Submit an updated drainage report meeting current criteria

FINAL DRAINAGE REPORT

FALCON ACRES SUBDIVISION

JPS Project No. 020506

DEVELOPED DRAINAGE PLAN

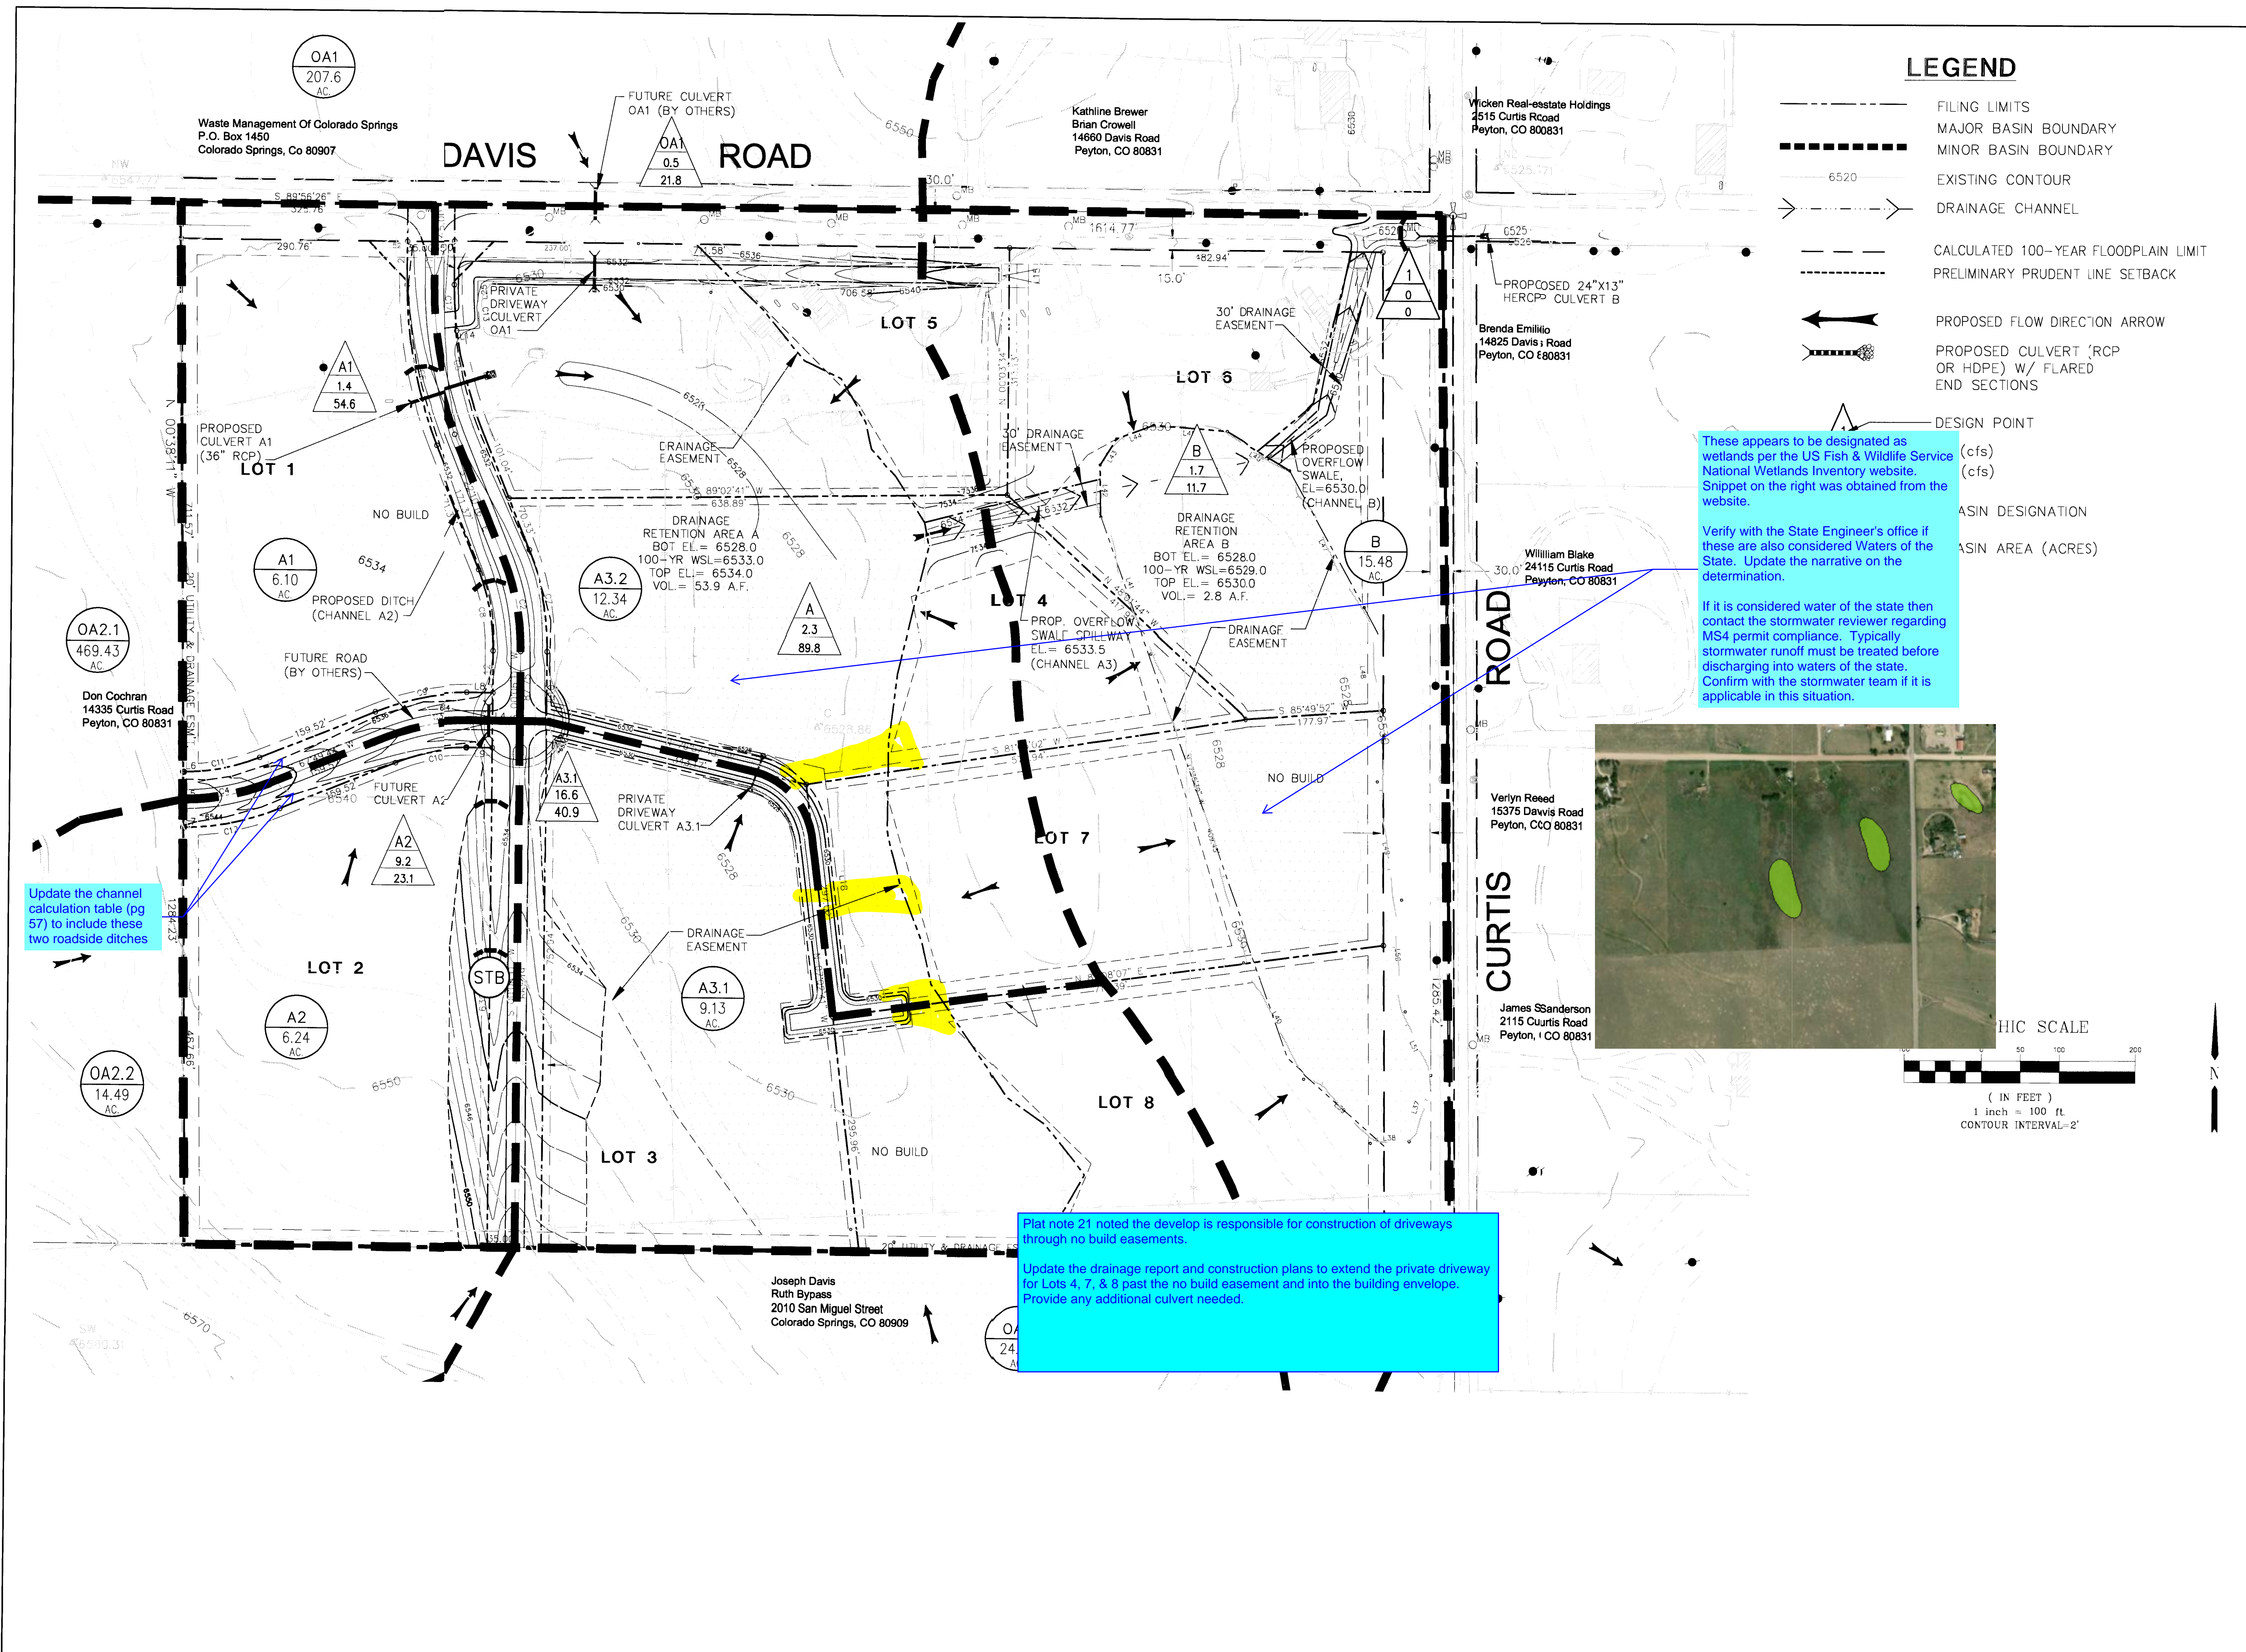
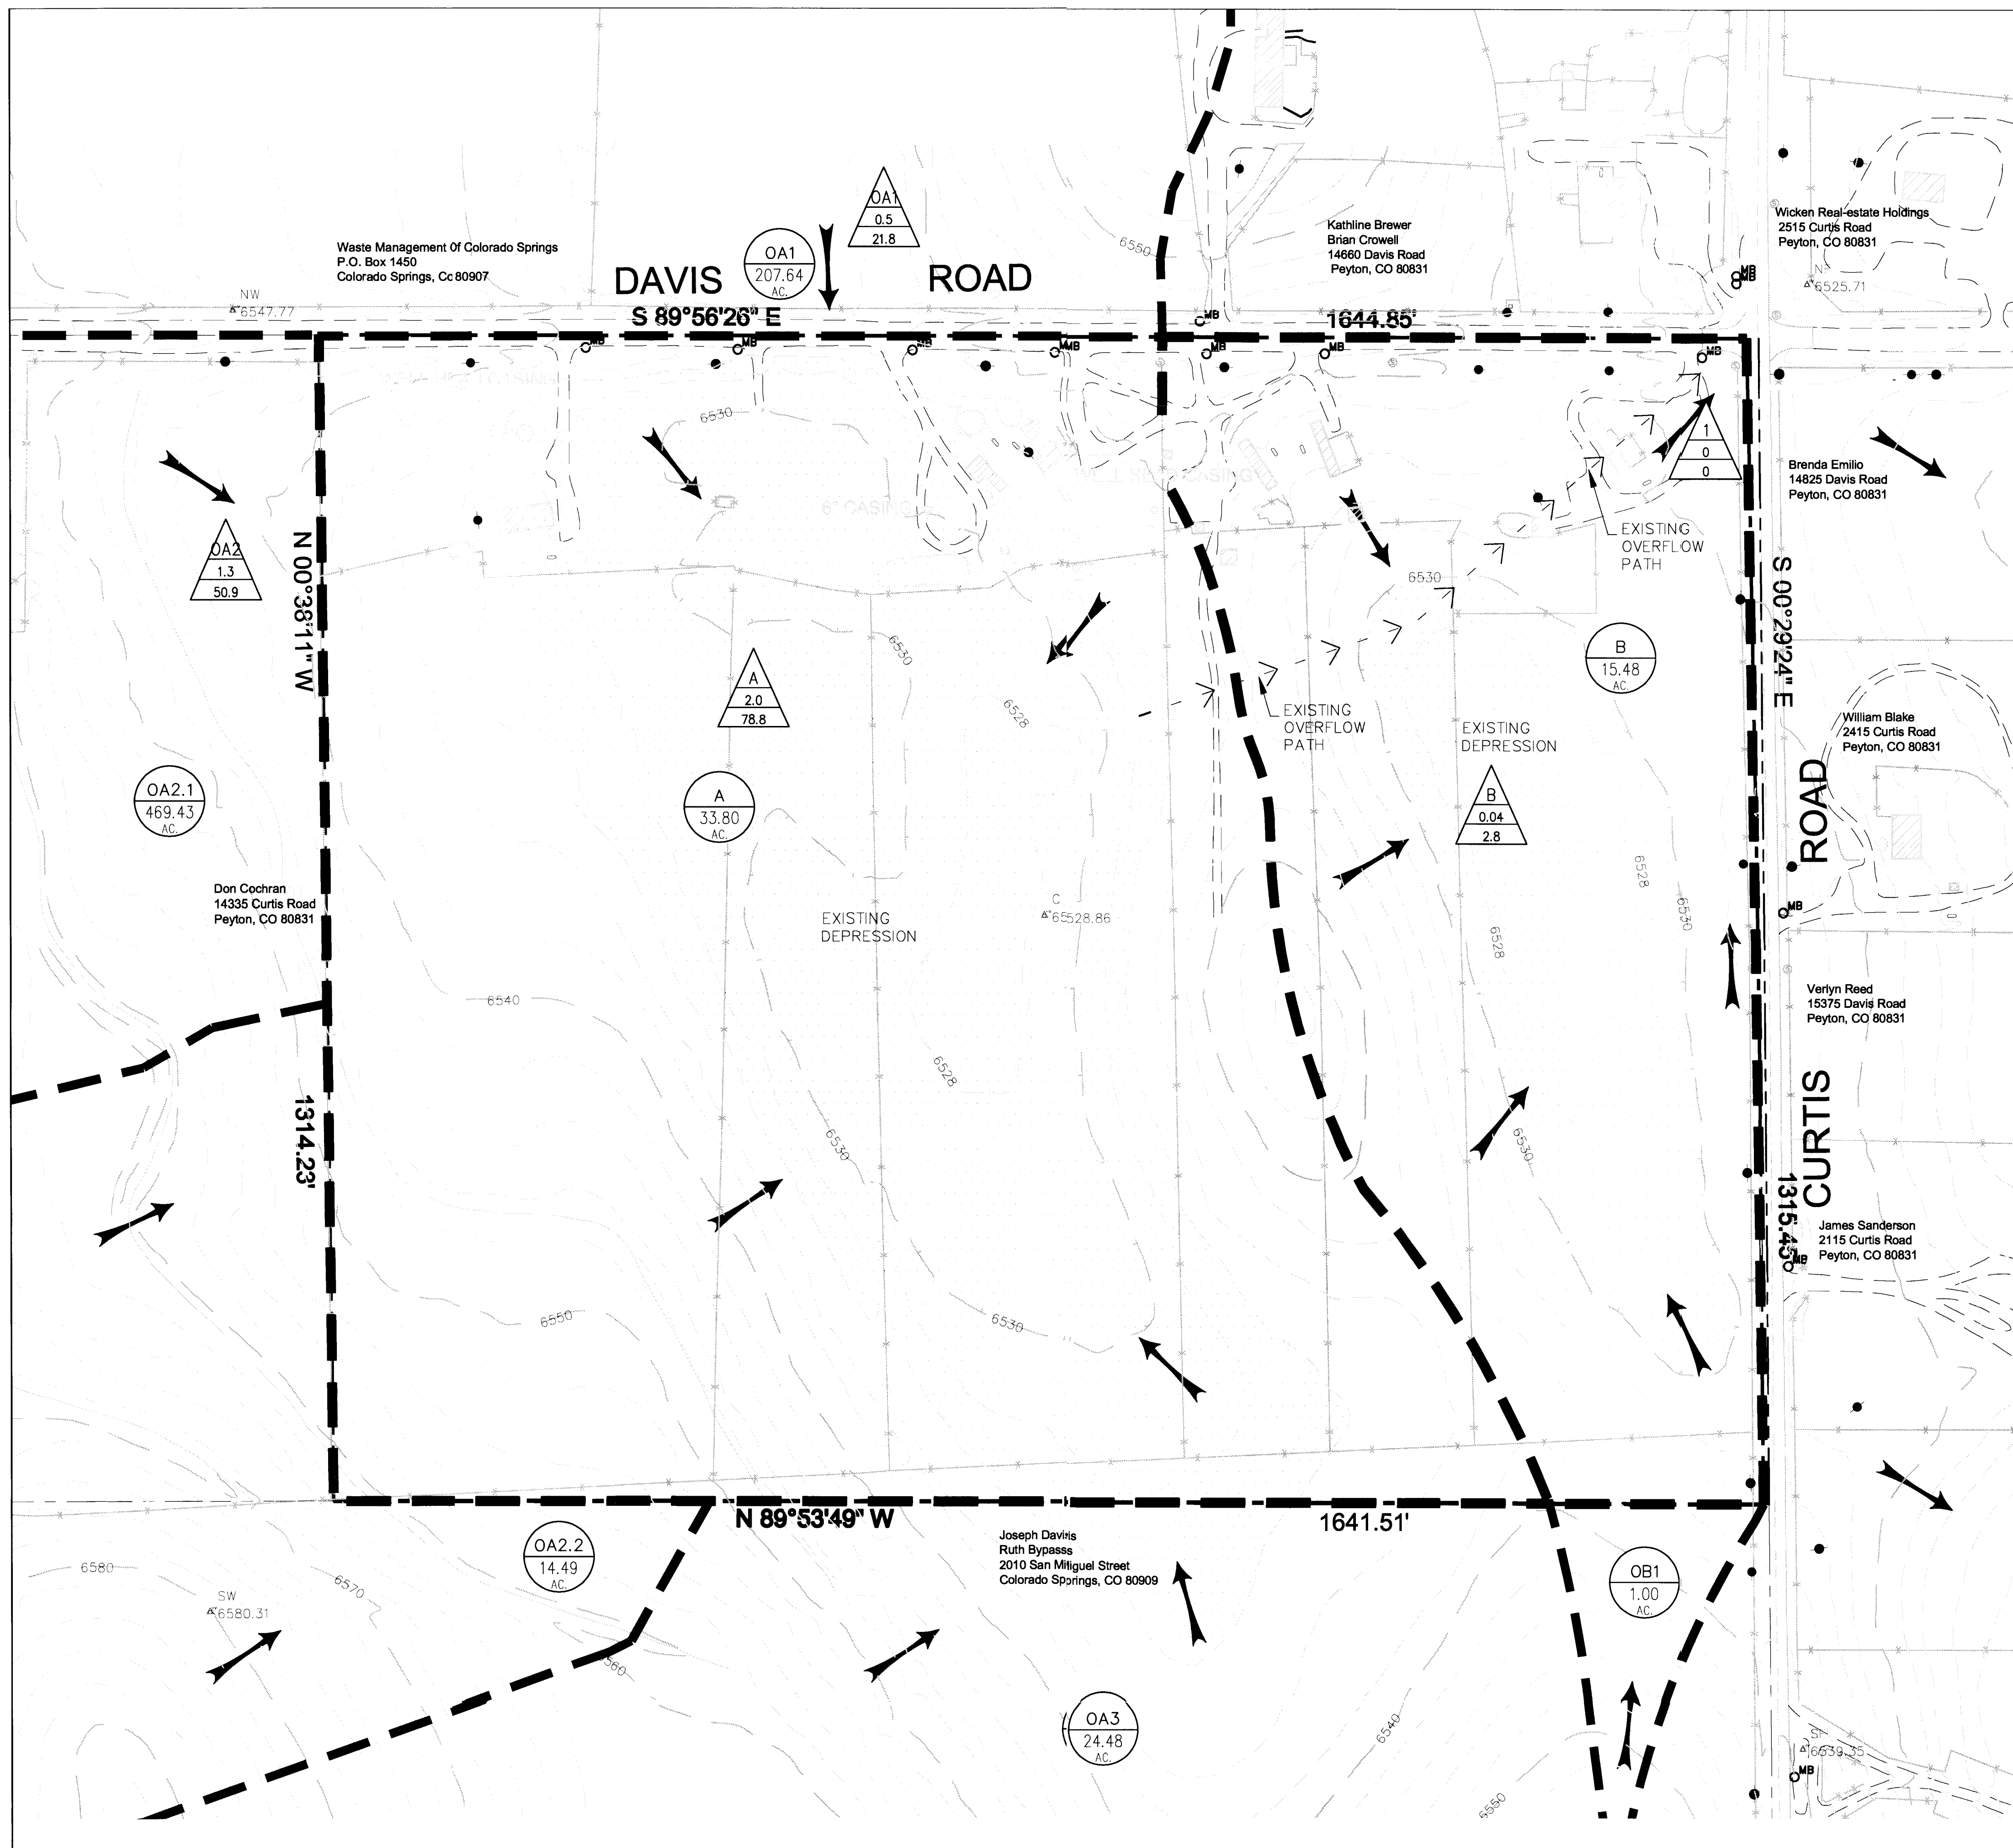
Upload a clearer drainage map. The existing contours are difficult to read. Unable to tell what elevation the drainage easement follows.

Update the channel calculation table (pg 57) to include these two roadside ditches

Plat note 21 noted the developer is responsible for construction of driveways through no build easements. Update the drainage report and construction plans to extend the private driveway for Lots 4, 7, & 8 past the no build easement and into the building envelope. Provide any additional culvert needed.
